# UNITED STATES PATENT AND TRADEMARK OFFICE

10/594,849

Hans-Georg Brauer

<b>Office Action Summary</b>	<b>Application No.</b> 10/594,849	<b>Applicant(s)</b> BRAUER ET AL.	
	<b>Examiner</b> Jerry Redman	<b>Art Unit</b> 3634

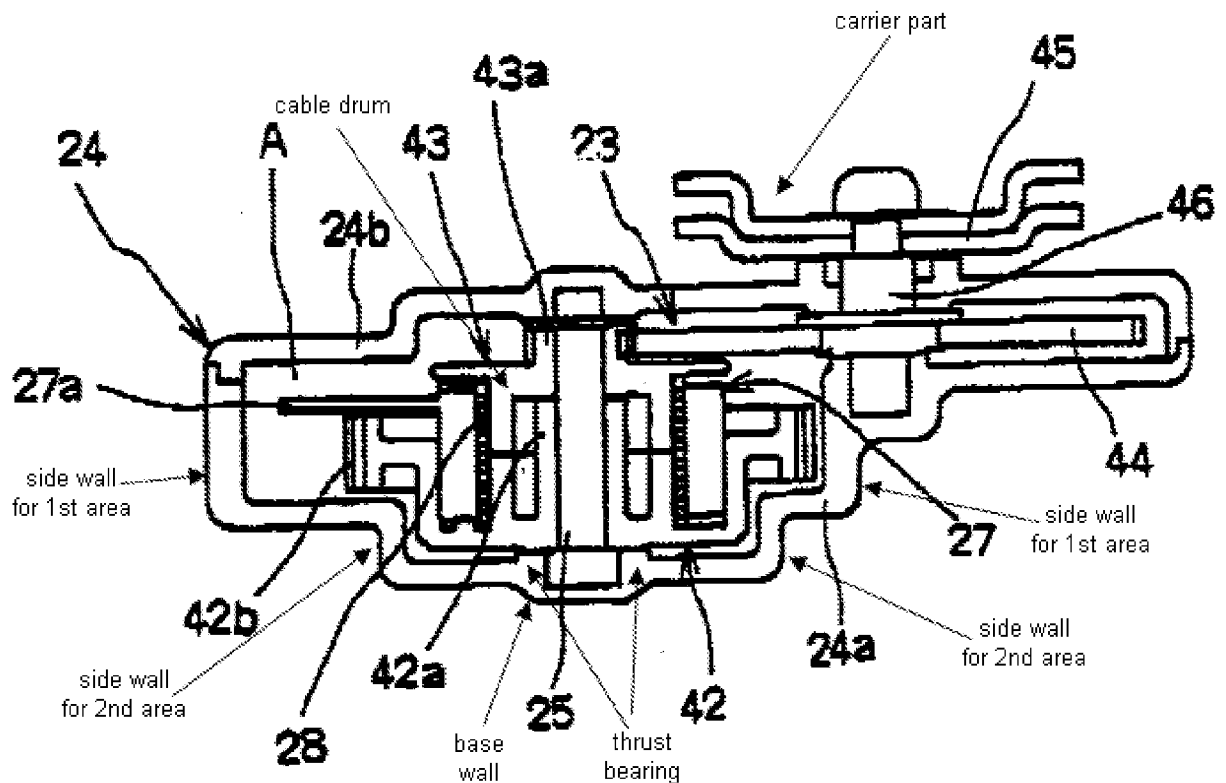
Claims 1-3, 5, 8-12, and 15 are rejected under 35 U.S.C. 102(b) as being anticipated by Shimizu (6,758,012 B2). As shown in detail below, Shimizu (6,758,012 B2) discloses a vehicle having a vehicle door (column 3, line 14, i.e.,) having a module (all inner mechanisms of a vehicle door), a carrier part (24) integrally formed with a drum housing (24a) having side walls, a back wall having a thrust bearing integrally formed thereon, and the housing (24a) having a first diameter area (see Figure below) and a second diameter area larger than the first diameter area (see Figure below).
